Access Compliance Report

Public Rights-of-Way

(Curb Ramps)

Intersection ID: 4999	Main Street: E_MALLARD_CREEK_CHURCH_RD	Cross Street: STONE_QUARRY_RD	Location: S
ADA ID: 6332C158D5BA	Ramp Type: Perp	Initial Pass/Fail: Fail	Overall Compliance: No
		Severity Score: 37.5

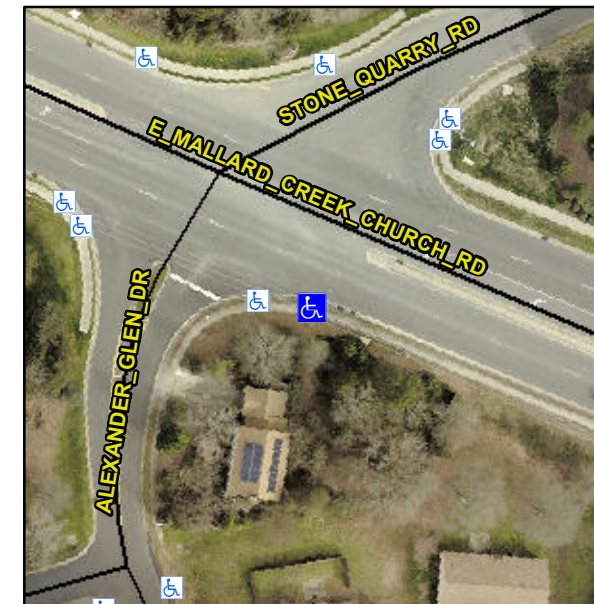
R304.2.2, R304.5.3

Compliance	Description	Data	Compliance	Description	Data
N/A	Ramp Length (in)	73.0	No	Ramp Slope (%)	14.4
Yes	Ramp Width (in)	48.0	No	Ramp XSlope (%)	6.7
N/A	Flare Type LT	N/A	N/A	Flare Type RT	N/A
N/A	Flare Slope LT (%)	N/A	N/A	Flare Slope RT (%)	N/A
N/A	Flare Traversable LT?	N/A	N/A	Flare Traversable RT?	N/A
N/A	Landing Length (in)	N/A	N/A	DWS Provided?	N/A
N/A	Landing Width (in)	N/A	N/A	DWS Contrast?	N/A
N/A	Landing Slope (%)	N/A	N/A	DWS Length (in)	N/A
N/A	Landing X Slope (%)	N/A	N/A	DWS Full Width?	N/A
N/A	Landing Curb? (Y/N)	N/A	N/A	DWS Offset (in)	N/A
N/A	Shared Landing?	N/A			
N/A	Gutter Ponding?	N/A	N/A	Gutter Slope (%)	N/A
N/A	Gutter Lip Ht (in)	N/A	N/A	Gutter X Slope (%)	N/A
N/A	Painted X Walk1?	No	N/A	Painted X Walk2?	N/A
	X Walk 1 Direction	To NE		X Walk 2 Direction	N/A
N/A	X Walk 1 Width (in)	N/A	N/A	X Walk 2 Width (in)	N/A
	X Walk 1 Slope (%)	2.5		X Walk 2 Slope (%)	N/A
	X Walk 1 X Slope (%)	5.6		X Walk 2 X Slope (%)	N/A

Remove & Replace Entire Ramp.
